ADDENDUM 1

DATE: 01/30/18
PROJECT: UCT Expansion Interior Buildout
RFP NO: RFP 744-R1805 – UCT Expansion Interior Buildout
OWNER: The University of Texas Health Science Center at Houston
TO: Prospective Proposers

A3 ELEVATION - GUARDRAIL WEST
SCALE: 3/8" = 1'-0"

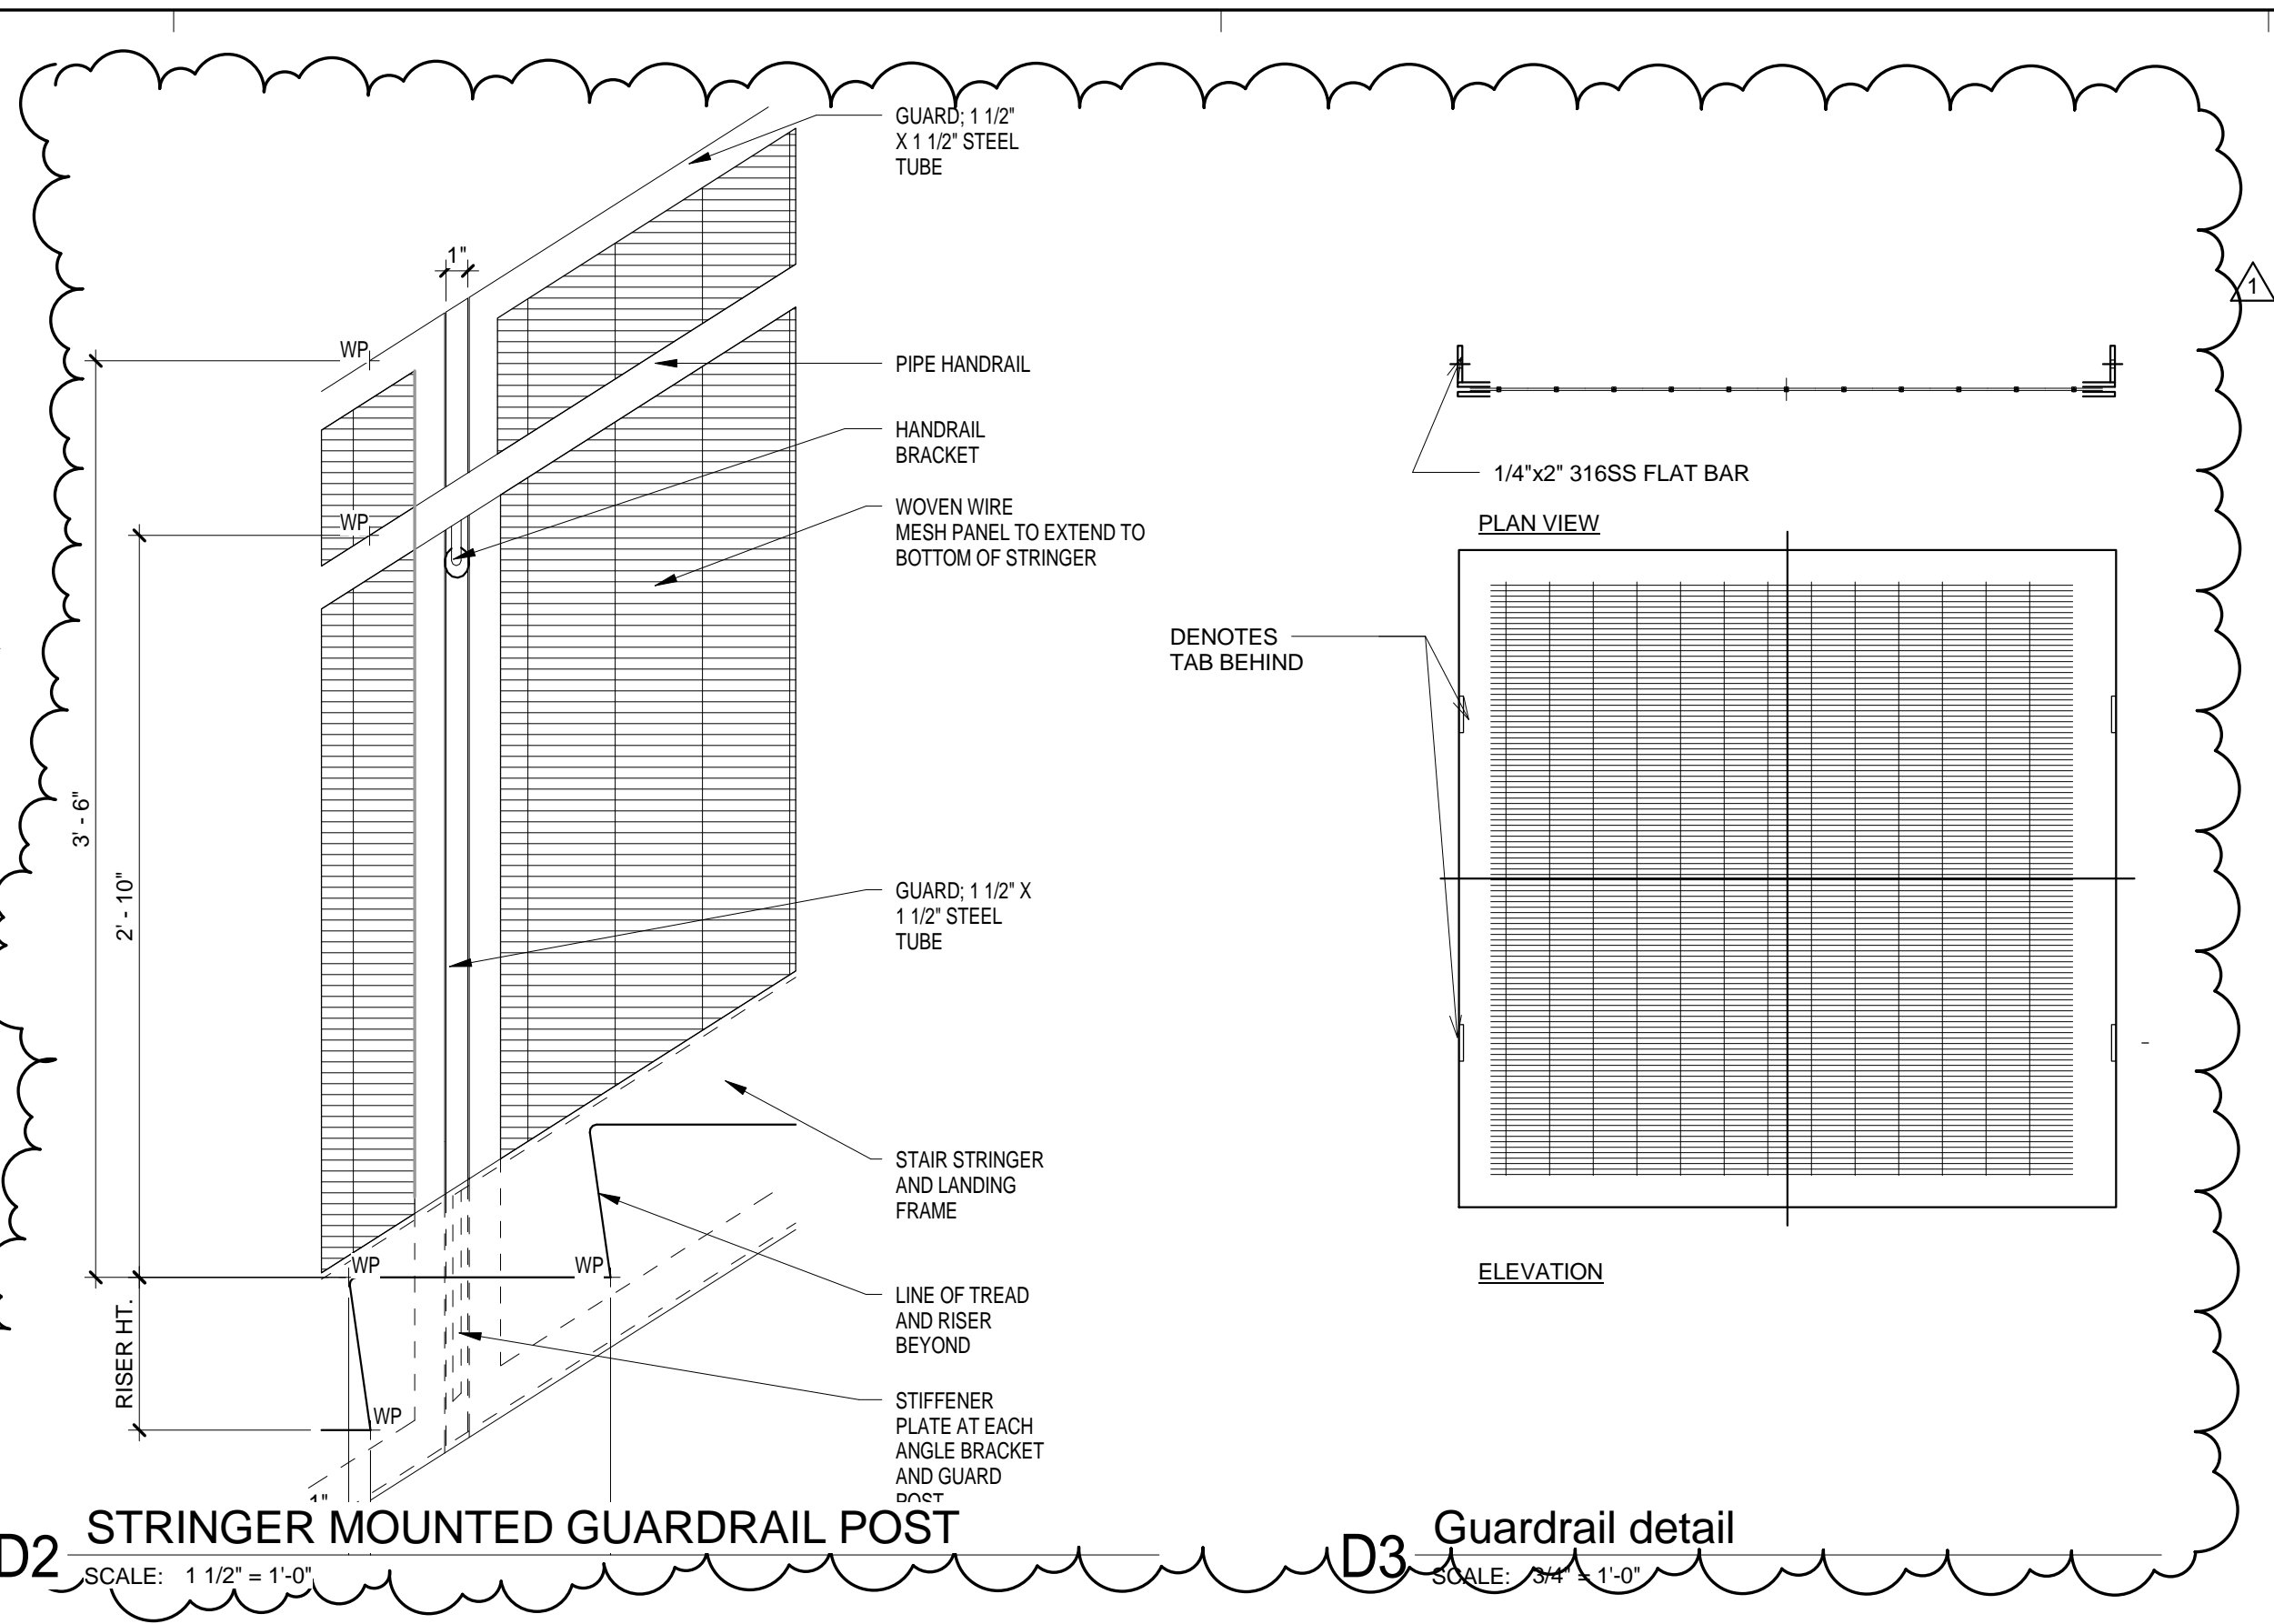
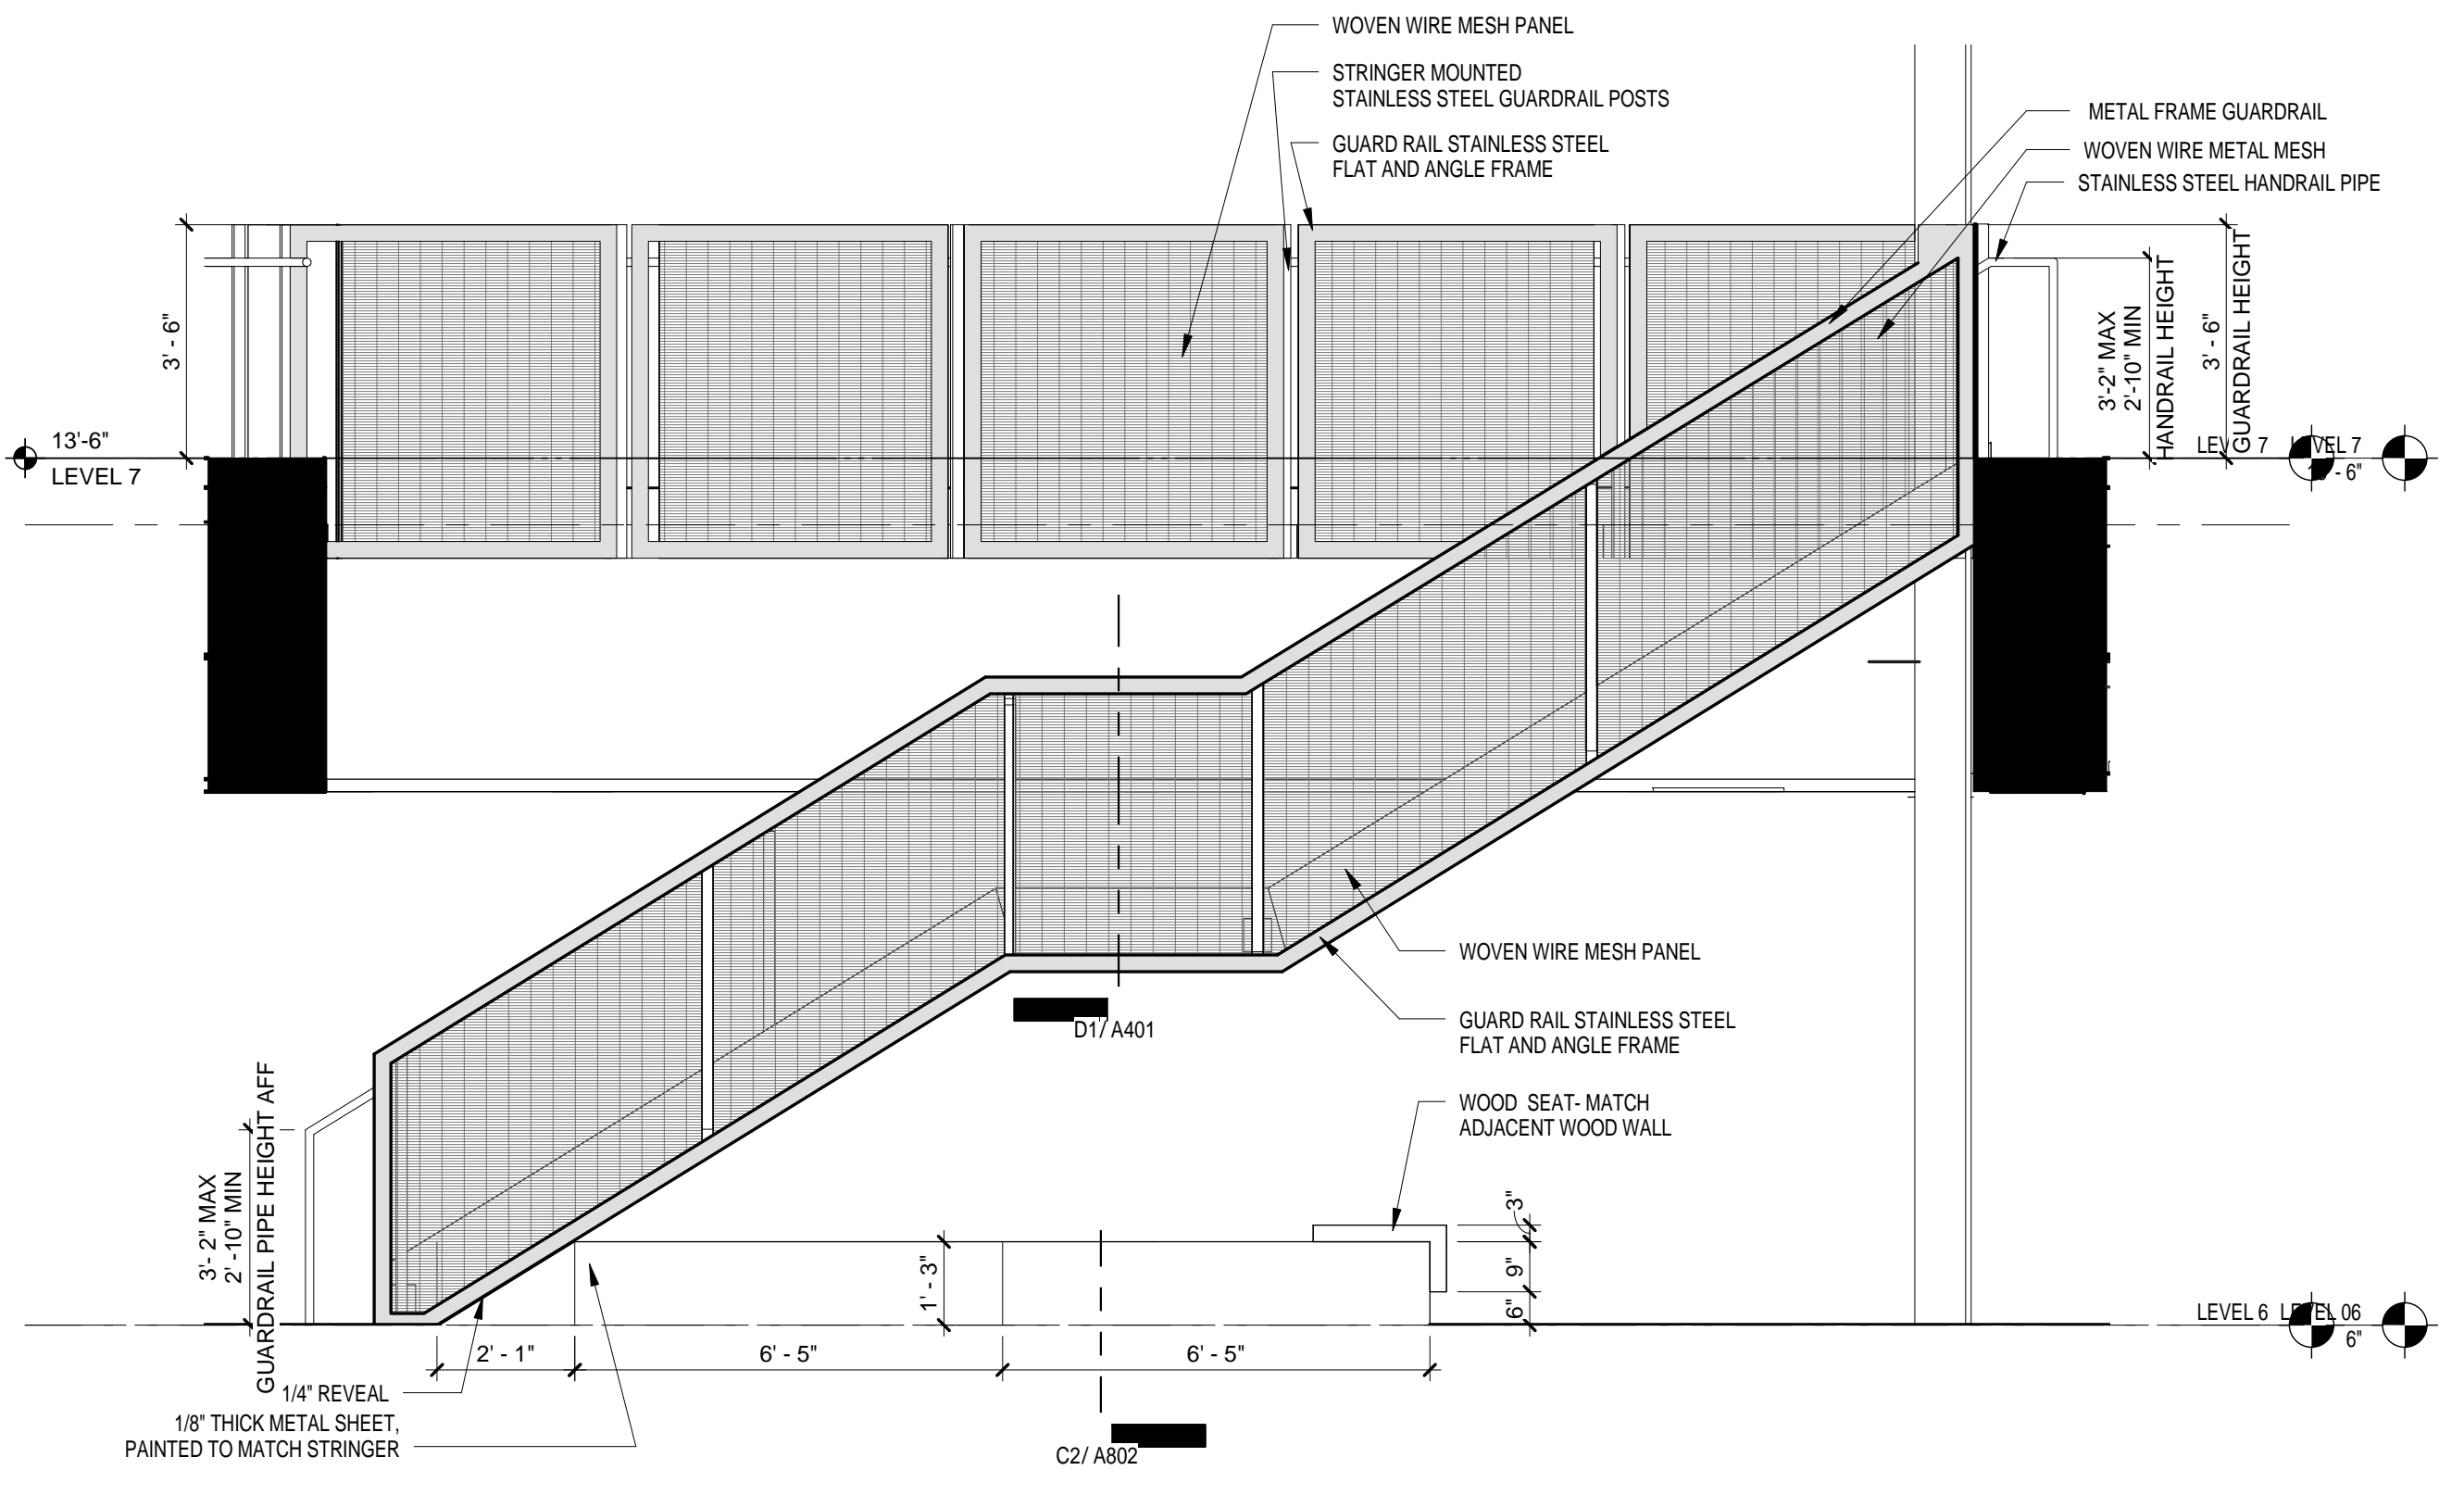
31. Sheet A401 – Please provide the following clarifications:

a. Detail C1 – Please provide detail for Guard Rail Stainless Steel “Flat and Angle Frame”

b. Detail C3 – Please clarify how mesh support tubes are mounted to the stringers.

c. Detail C3 – Detail indicates stainless steel fascia. Please clarify if this fascia is existing or part of this project installation. If part of this project, please provide details and location of stainless steel fascia.

d. Please clarify handrail. Details A1 & C1 indicate a single line rail, while A3 & D1 indicate a 4-line rail.

32. Sheet A401 – Detail C5 indicates wood flooring to match existing stair treads. Please provide wood floor material selection and specifications.

a. Is the extent of the wood flooring to be the hatched square shown in this detail only?

Provided

Vertical Support tubes to be mounted on stair stringer see drawing for notes

Stringer part of the core and shell project. No Steel Fascia to be used.

Single line handrail is to be provided

All details to be provided in Addendum 1 documents

Flooring and treads will be added into the interior Buildout set in an Addendum.
1 1/2" WALNUT WOOD TREAD
